AGENDA
DESIGN COMMISSION
Community Room, 3rd Floor
Arlington Heights Village Hall, 33 S. Arlington Heights Rd.
Arlington Heights, IL 60005
August 12, 2025
6:30 PM

MINUTES OF THE VILLAGE OF ARLINGTON HEIGHTS DESIGN COMMISSION

ARLINGTON HEIGHTS MUNICIPAL BUILDING
33 S. ARLINGTON HEIGHTS RD.
JULY 22, 2025

SP-1.0

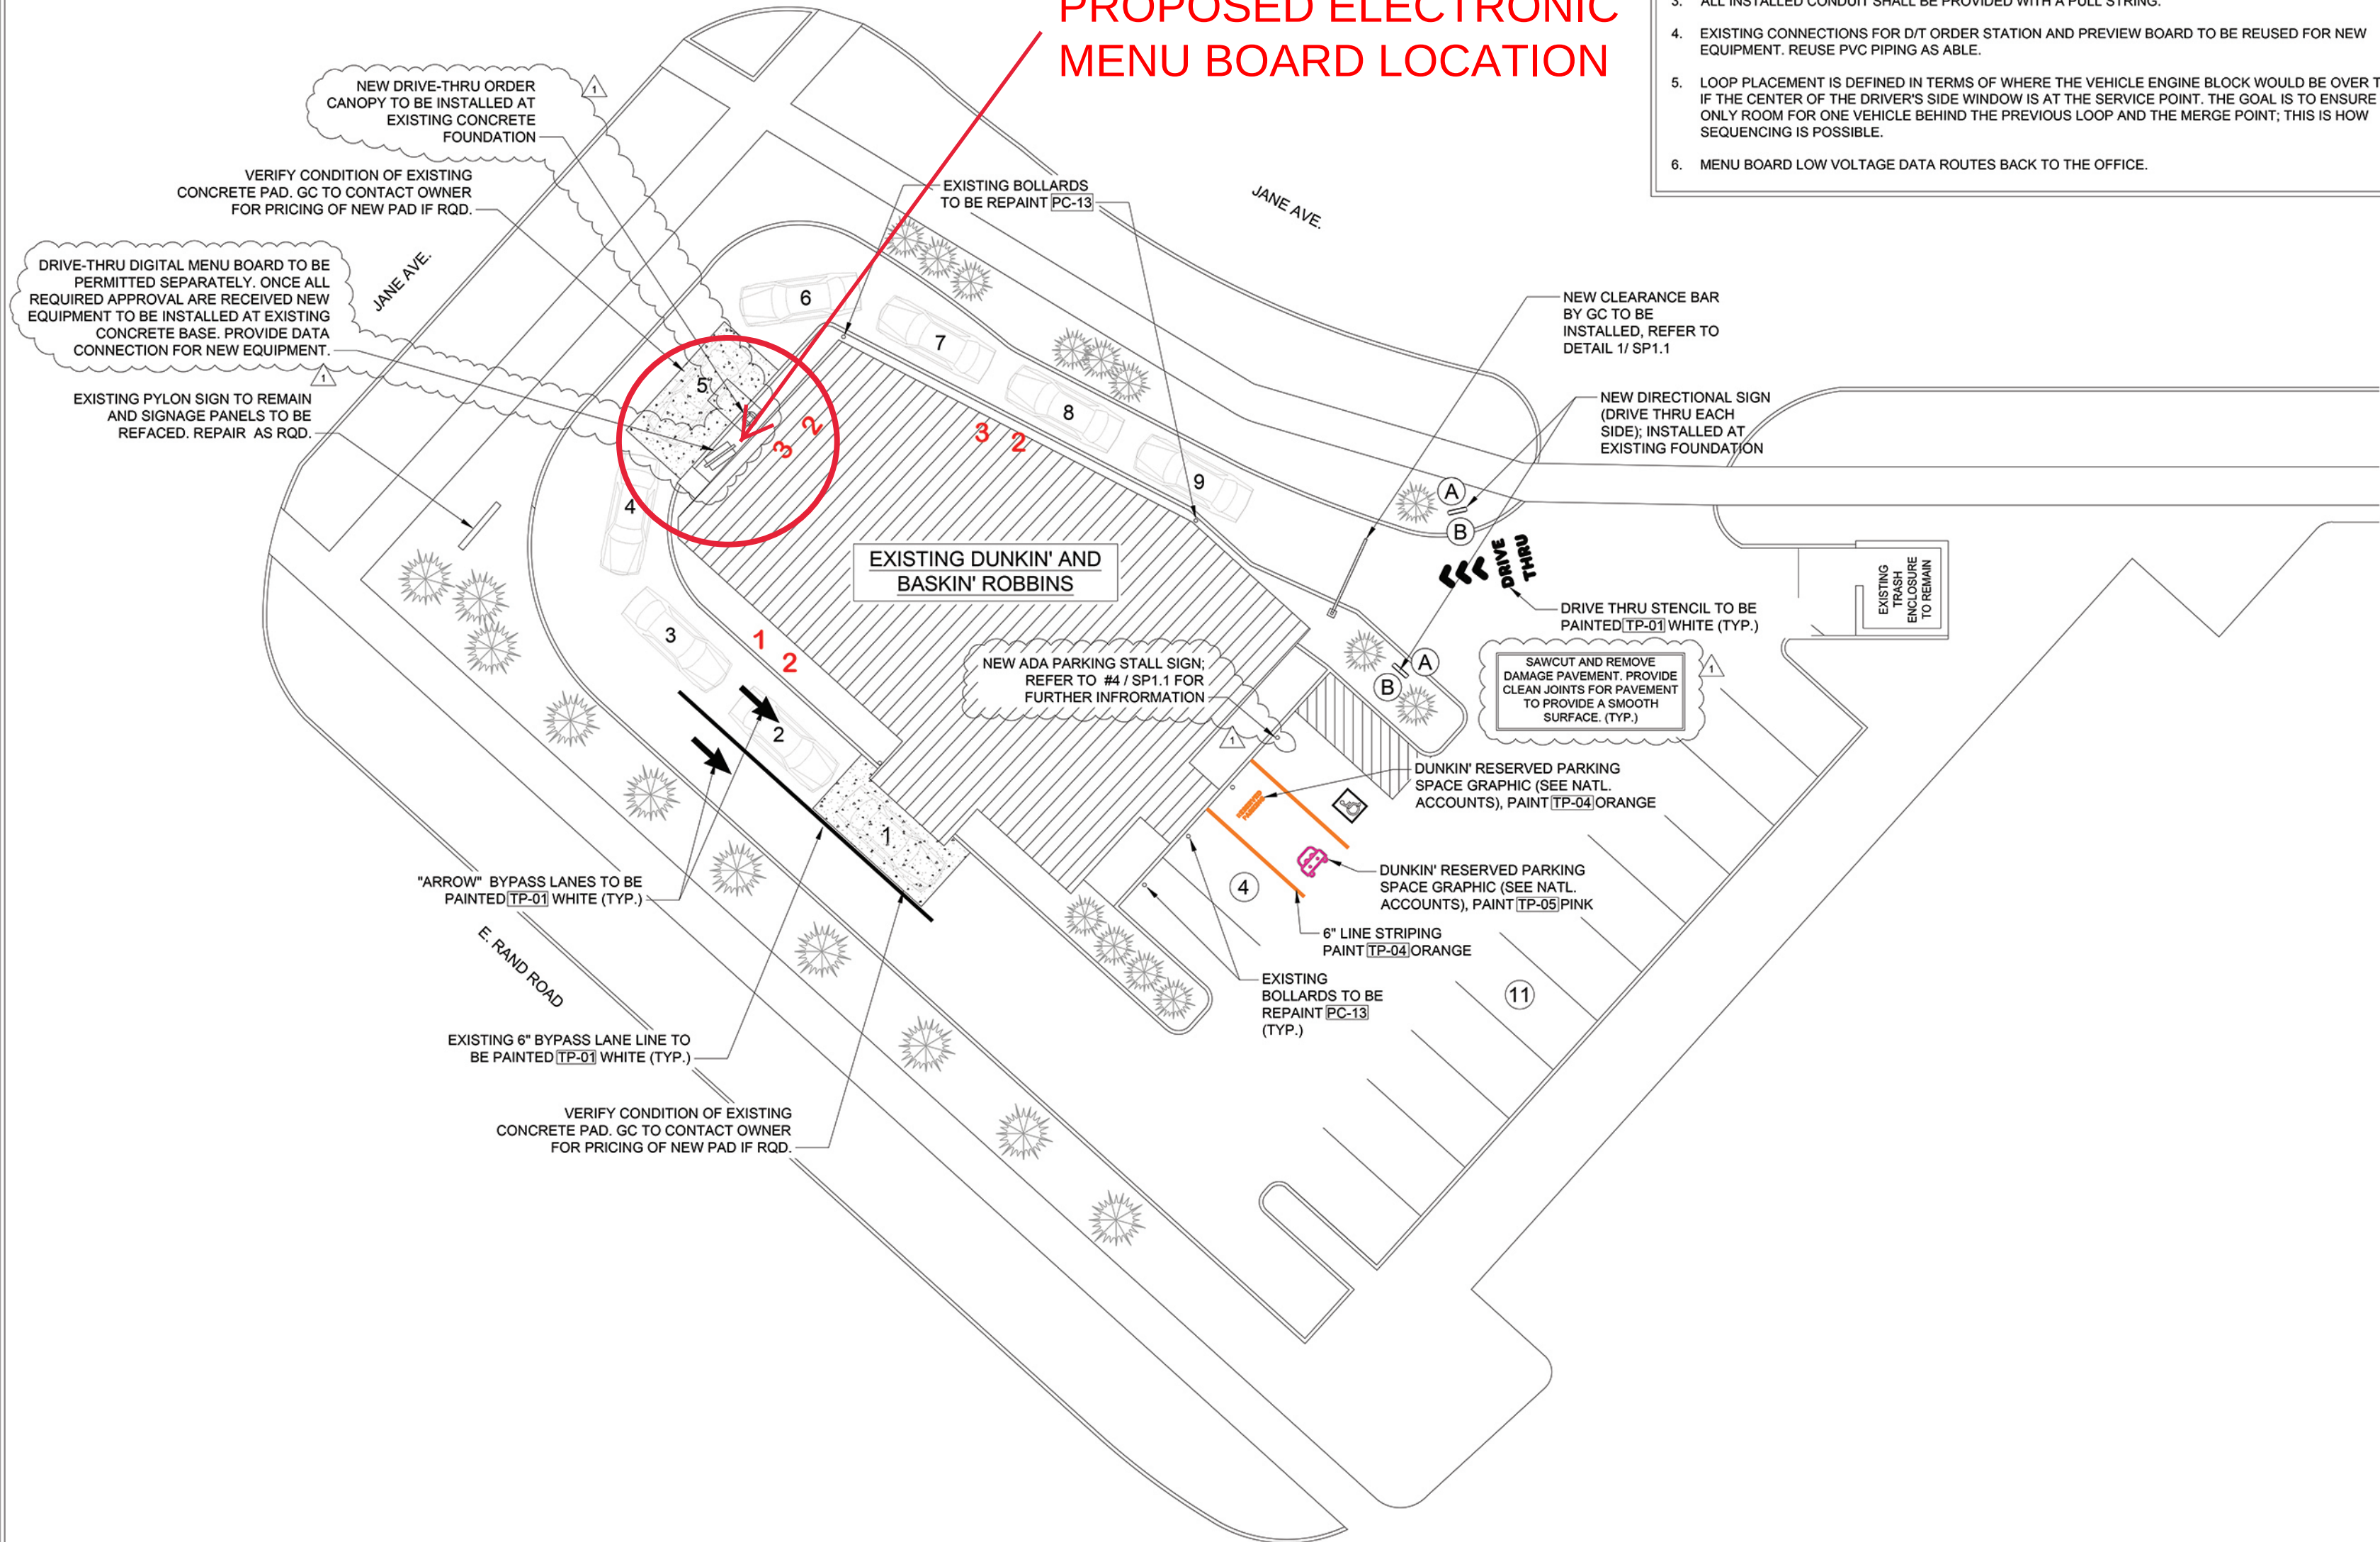
The existing Dunkin restaurant located at 1010 E. Rand Road is proposing to replace their existing conventional printed drive-through menu board with a new fully electronic menu board display along their existing drive-through lane. The electronic menu board is proposed to be installed in the same location as the existing menu board, which faces Jane Avenue, and is visible from both Jane Avenue and Rand Road. A new code-compliant order canopy will replace an existing speaker bollard.

The petitioner has submitted a letter addressing the sign variation criteria, which states that the proposed fully electronic menu board is necessary for both customer experience and operational efficiency, allowing the ability to quickly update prices and promotions. The petitioner states that the electronic menu board will not be a hazard or have a negative impact, but instead will be a modern and appealing enhancement. Having an electronic menu board will not provide a competitive advantage because many of their competitors already have them.

1. Provide new/additional landscaping to be approved prior to issuance of a permit to improve screening of the electronic menu boards from the street.
2. The electronic menu boards will display drive-through menu signage only, and will not be used to display any other advertisements.

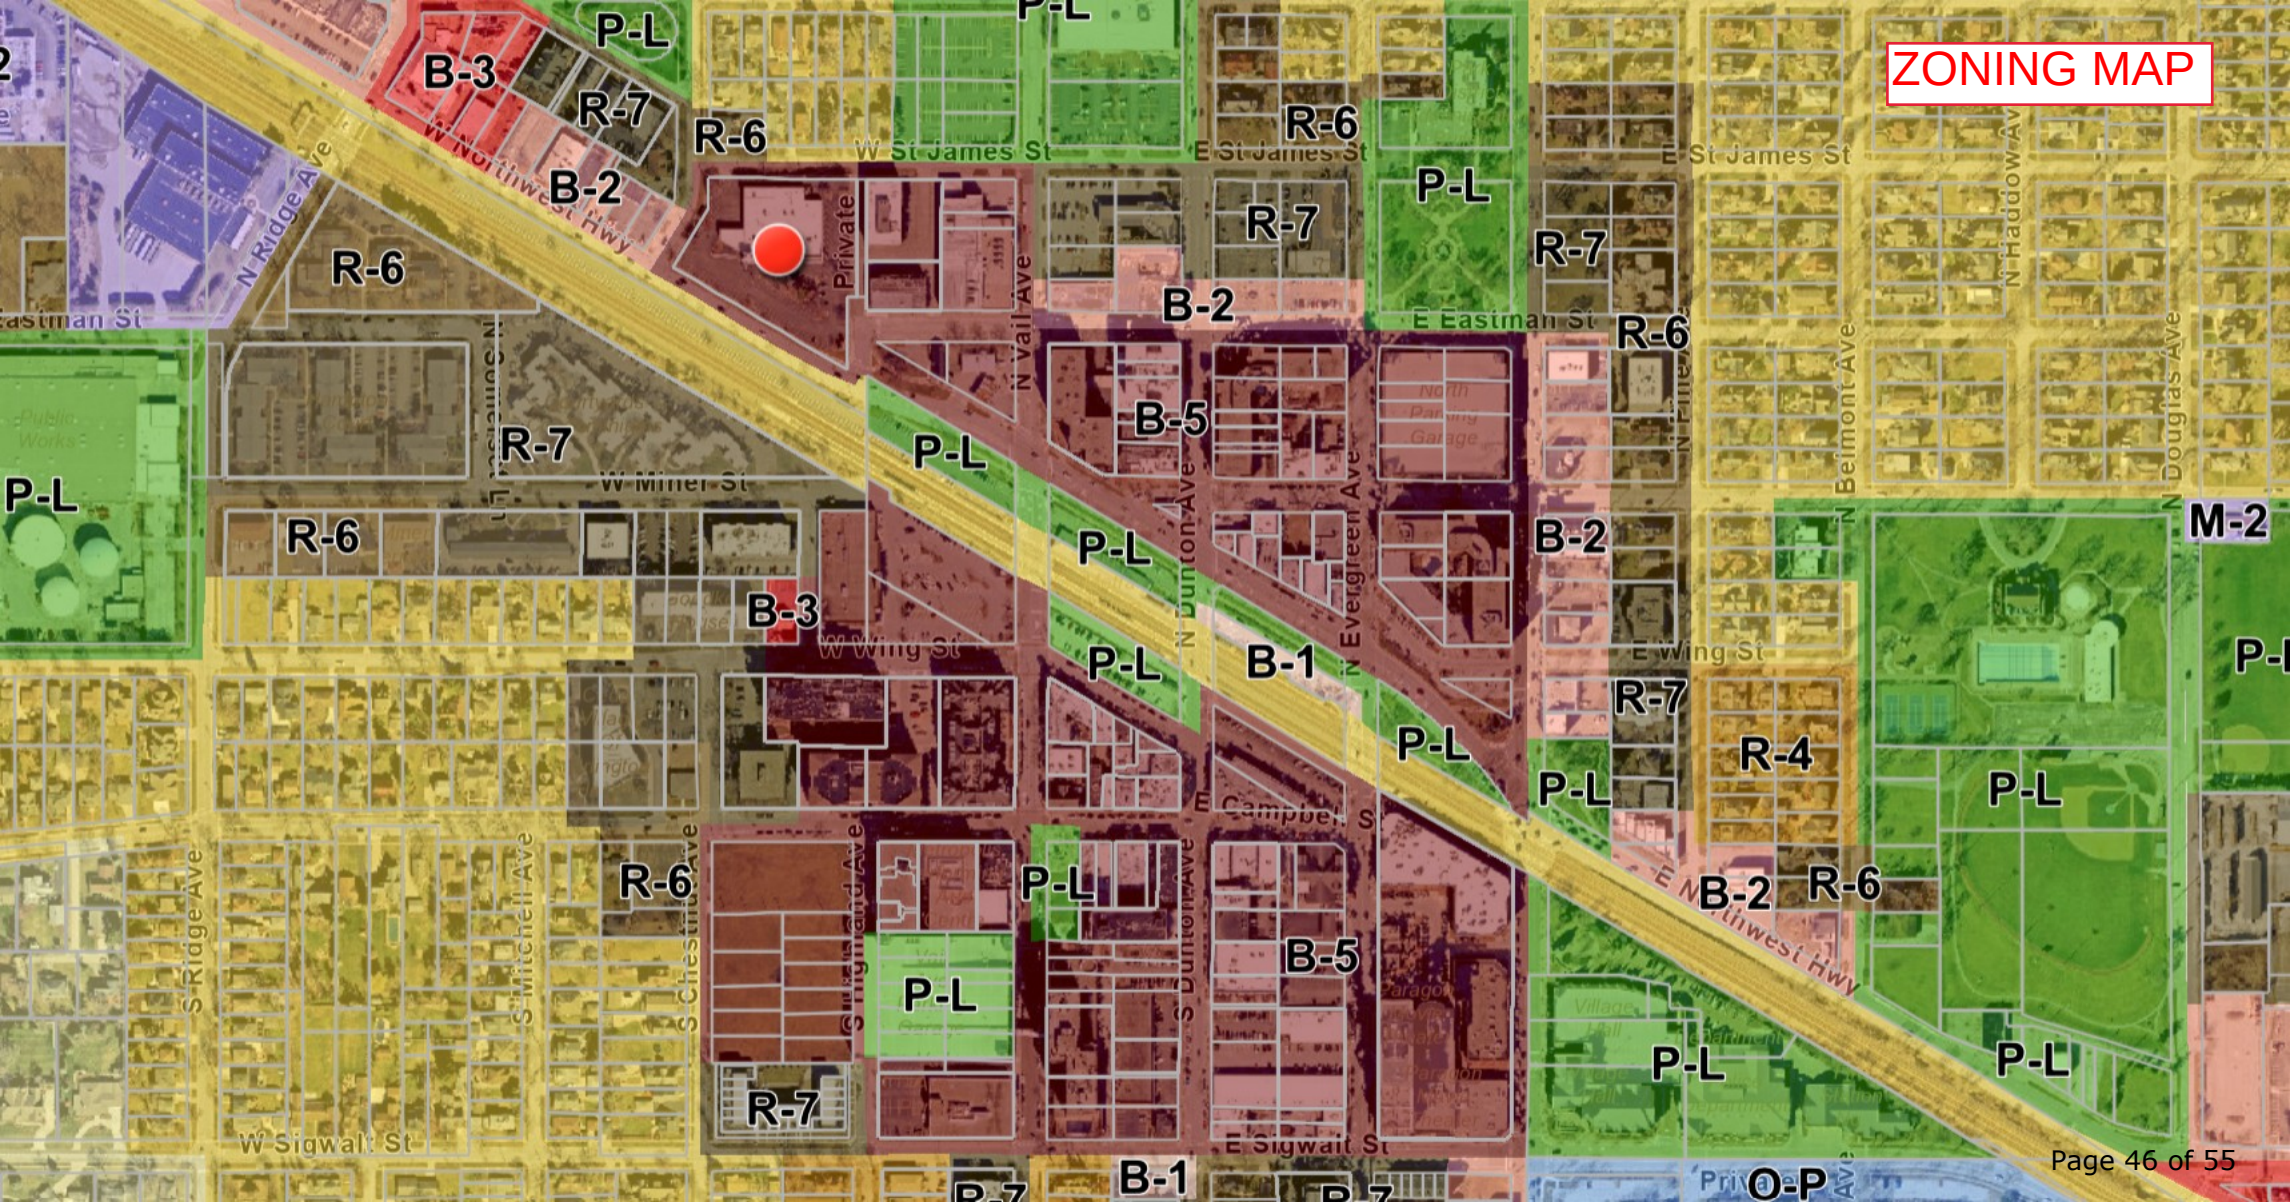
At this time, the petitioner is requesting to remove both of the existing signs, and install one new multi-tenant ground sign. A new variation is required due to the size of the proposed sign which is 66 sf, where 35 sf is the maximum allowed. The proposed new sign does comply with all other applicable sign code requirements.

The current Village Bank & Trust sign has very limited visibility from Northwest Highway, and it is only visible when traveling westbound. The current Baird & Warner sign has good visibility, but the pole mounted design does not fit the character of the Downtown. Therefore, Staff does support the proposal to replace the two existing signs with a new single multi-tenant sign, which will provide good visibility for both businesses from eastbound and westbound traffic on Northwest Highway. Combining the two tenants on one sign reduces the total number of signs on the site, and the proposed monument style is a nice design improvement compared to the existing pole mounted sign. The height of the proposed sign does comply with the maximum allowed 10-foot height limit.

This recommendation is subject to compliance with the plans received 6/20/25, Federal, State, and Village Codes, regulations, and policies, and the issuance of all required permits, and the following conditions:
